**METROPOLITAN GOVERNMENT OF NASHVILLE AND DAVIDSON COUNTY**

**STAFF RECOMMENDATION**  
**2020 10<sup>th</sup> Avenue South**  
**April 17, 2019**

**Application:** Demolition-Partial; New Construction—Addition;  
**District:** Waverly-Belmont Neighborhood Conservation Zoning Overlay  
**Council District:** 17  
**Map and Parcel Number:** 10509041200  
**Applicant:** Seth Jennings  
**Project Lead:** Melissa Baldock, melissa.baldock@nashville.gov

Figures 4 (left) is the front door frame, which is likely original. Figure 5 (right) is the drawing showing a different door frame and configuration.

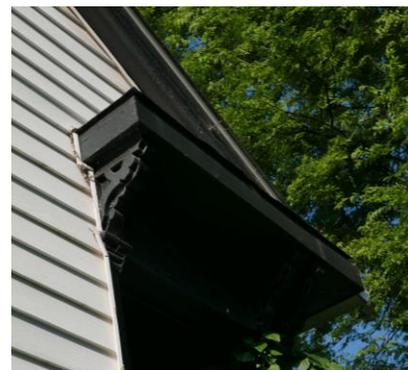
Partial Demolition: The applicant is proposing several changes to the historic house, which are partial demolition. On the front façade, the drawings show a different door frame configuration than what is extant (Figures 4 & 5). Staff finds that the arched transom and door frame are significant Italianate details that are likely original to the house and should be retained. However, the doorframe and transom do not appear on the drawings. Other details on the front porch and front façade, including the dentils and porch brackets, do not appear on the drawings and staff recommends that they be retained (Figures 6 & 7).

Staff recommends disapproval of the partial demolition of the front door frame and other detailing on the historic house, finding that it does not meet Section V.B.II. for appropriate demolition but rather meets Section V.B.I. for inappropriate demolition.

Figure 10. Staff finds that the removal of the appendage at the rear of the house to be appropriate.

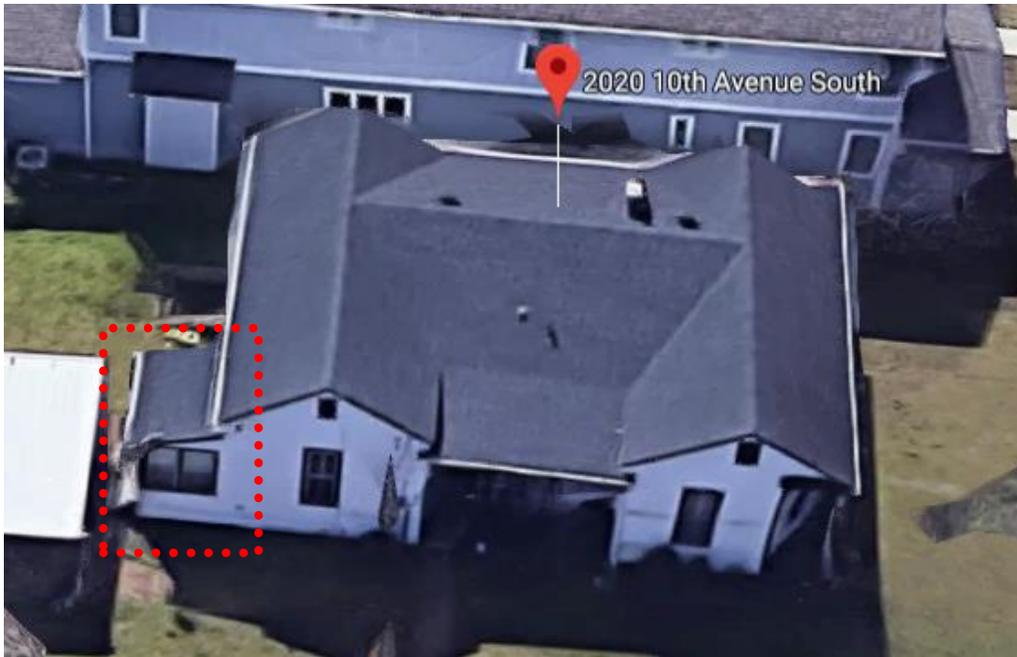
The applicant is proposing further to remove a small, rear porch portion of the house (Figure 10). The rear porch of the house is not seen in any of the older maps for the house and was therefore likely constructed after 1957. The structure has a separate roof form from the rest of the house, and staff finds that its date of construction, location at the rear of the house, and roof form do not contribute to the historic character of the house. Finally, the applicant is proposing to remove a detached rear carport and a detached garage (Figure 11). Neither structure appears on the 1957 Sanborn map, and neither contributes to the historic character of the house, the site, or the overall neighborhood. Staff therefore finds demolition of the rear porch, garage, and carport to be appropriate.

**Recommendation Summary:** Staff recommends approval of the window opening alterations and the demolition of the rear addition, detached garage, and detached carport, finding that their demolition meets the guidelines’ Section V.B.II. for appropriate demolition.

Figure 12. The side porch that will be enclosed. .

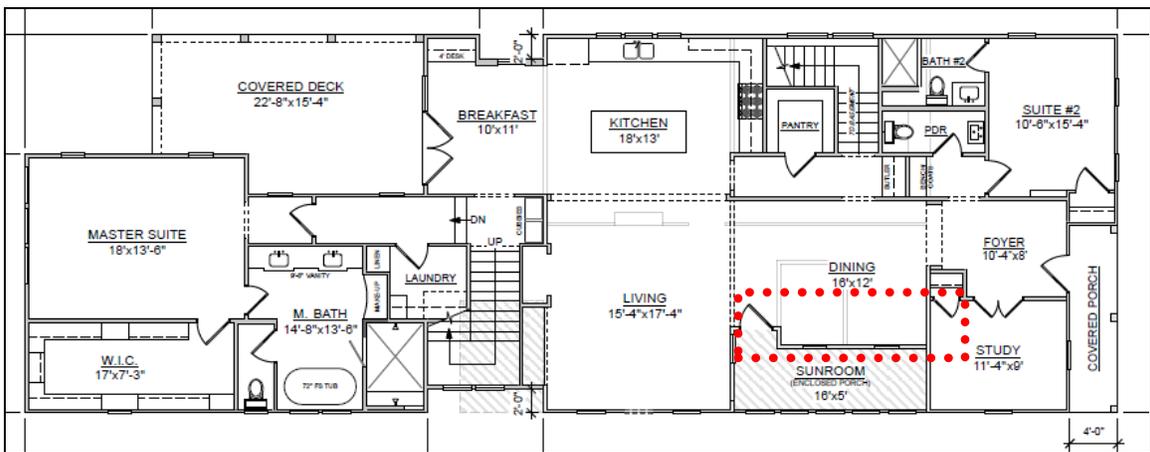
Design: Staff finds that the addition's height, scale, and taller roof form contrast greatly with the historic house at 2020 10<sup>th</sup> Avenue South. In addition, staff finds that the design of the proposed enclosure of the side porch is not appropriate (Figures 12, 13, and 14). Although the plans show that the exterior wall will remain, staff finds that the design of the enclosure lacks the transparency and openness required to indicate that this was once an open porch. The Sanborn maps from 1908, 1914, and 1957 all show that this area was always a side porch (Figures 15, 16, and 17). Staff finds the side porch configuration is a significant part of this historic house's form and should be preserved. Staff therefore recommends that the side porch element be designed to be more open in nature so – for instance all glass or screened – so that the exterior wall can still be read through the enclosed porch. The addition of posts to the enclosure would further help to make the element read more as an enclosed porch rather than a new wall.

Because of the large height, scale, and roof form, and because the design of the porch enclosure is not sufficiently open in nature and does not read as a porch area, Staff finds that the project’s design does not meet Sections IV.A, IV.B, IV.C, and IV.F. of the design guidelines.

**SITE PLAN**  
2020 10TH AVE S

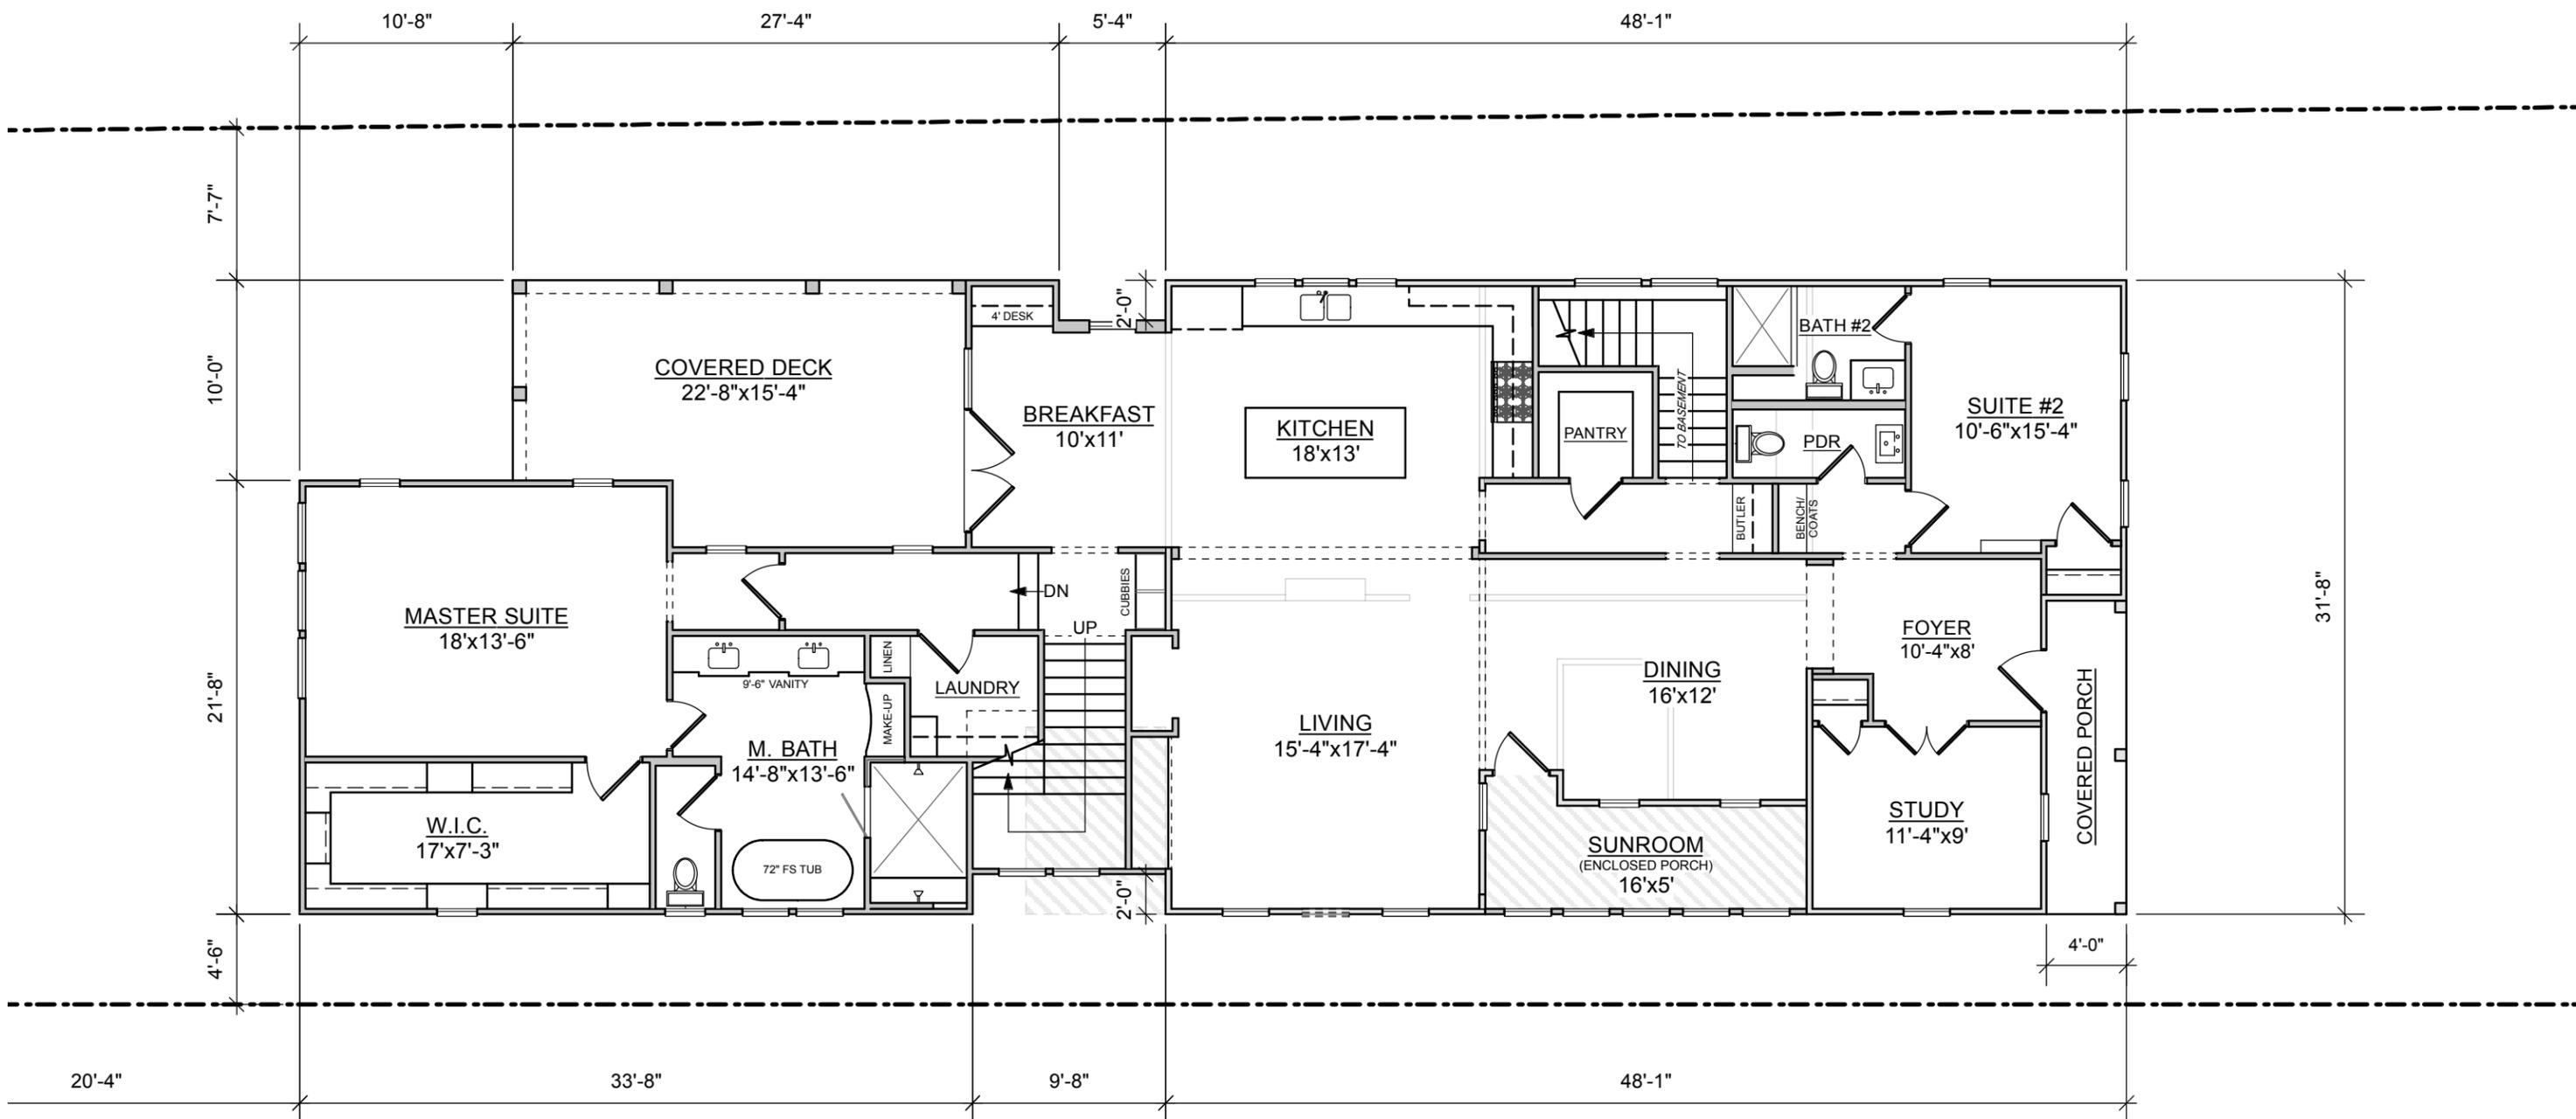
**Setback & Rhythm of Spacing:** The site plan shows that the addition meets all base zoning setbacks. It shows that the addition will be five feet (5’) from the left side property line and seven feet, three inches (7’3”) from the right side property line. It will be over fifty feet (50’) from the rear property line. Staff notes, however, that the first floor plan shows different setbacks. It shows the addition as being four foot, six inches (4’6”) from the left side property line and seven feet, seven inches (7’7”) from the right side property line. Since the official survey for the lot shows the existing house as being five feet (5’) from the side property line and both plans show the addition as lining up with the historic house, staff assumes that the site plan is correct and the first floor plan is erroneous. Although staff finds that the proposed setbacks as shown on the site plan are appropriate and meet Sections III.C. and IV. of the design guidelines, staff recommends that all future drawings show the accurate setbacks.

**2020 10th AVE S**  
**ELEVATIONS**

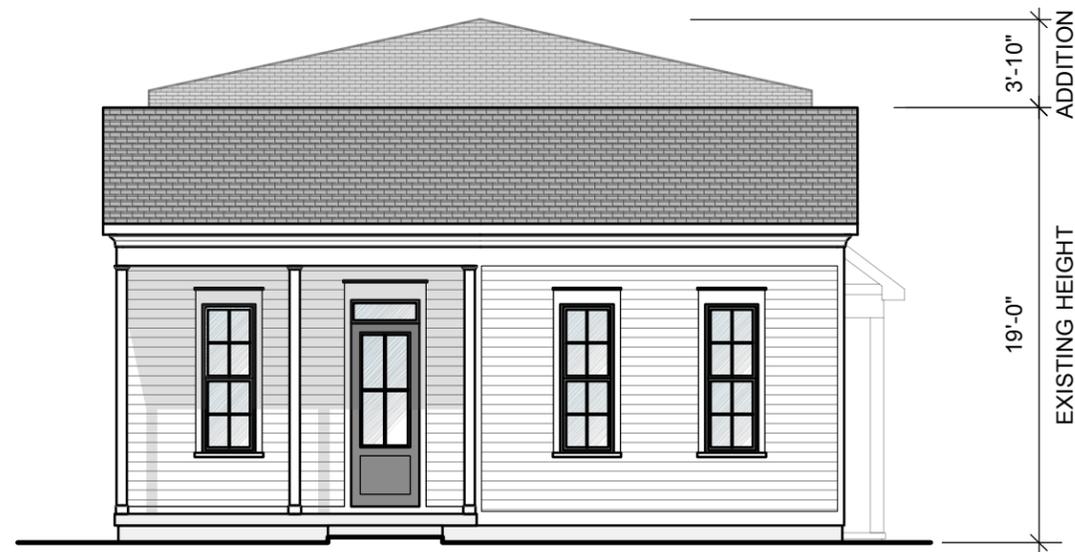
Height & Scale: The applicant is proposing a two-story addition to this one story house. The addition is proposed to be three feet, ten inches (3'10") taller than the historic house. Where the addition ties into the rear of the historic house, its eave is six feet (6') taller than the eave of the historic house and about nine inches (9") taller than the historic house's ridge height. The design guidelines state, "*when a taller addition is the only option, additions to single story structures may rise as high as 4' above ridge of the existing building.*" In this case, staff does not see a taller addition as the "only option" for adding onto this house. There are no site constraints or easements to prevent the applicant from adding onto the rear with an addition that is no taller than the historic house. Even though the taller portion of the addition is inset two feet (2'), staff finds a two-story or even a one-and-a-half story addition to be inappropriate to this true one-story house.

Roof form: The proposed addition has pyramidal roof form that is not appropriate for this historic house. The taller eave heights on the side facades and the large amount of roof visible above the front façade are not appropriate for this one-story historic house. Staff finds that the addition’s roof form contrasts greatly with the roof form of the historic house. Staff therefore finds that the proposed roof form does not meet Sections III.E. and IV.C. of the design guidelines.

Staff also recommends disapproval of the addition, finding that its height, scale, design, removability, and roof form do not meet Sections III. and IV. of the design guidelines.
